MICHIE LANE PARK CONTRACT

CHANGE ORDER

MIDWAY CITY MICHELLE LANE PARK	
SITE PLAN	
280 E Main St, Suite 204 Midway, UT 84049 ph. (801) 729-2000	
DESIGN BY: CMB	DATE: 12 NOV 2018
DRAWN BY: CMB	REV: _____
SHEET	1.2

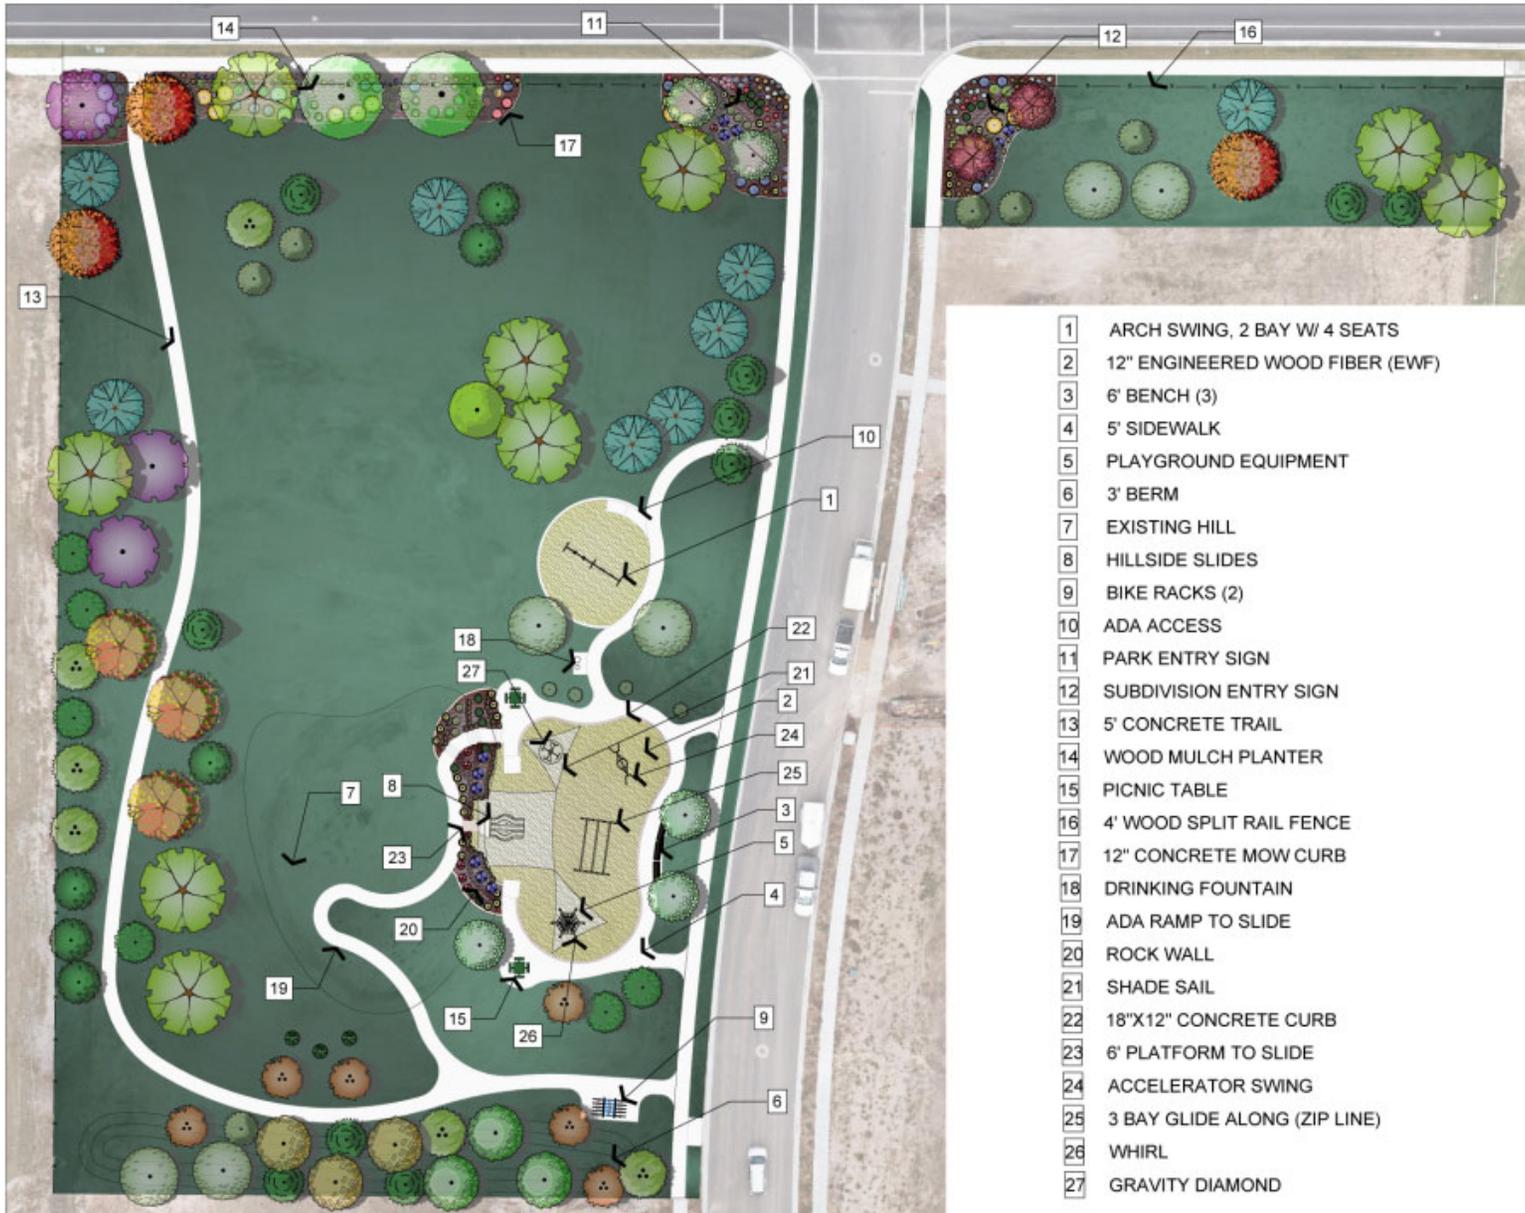
- Correction for 31 trees
 - 131 trees are needed for Michie Lane Park, Valais Park, & Cemetery
 - \$12,400 are required to purchase and plant 31 trees
- ADA Ramp
 - Cost for an ADA ramp across the park strip is \$4,400
- Change order total cost \$16,800
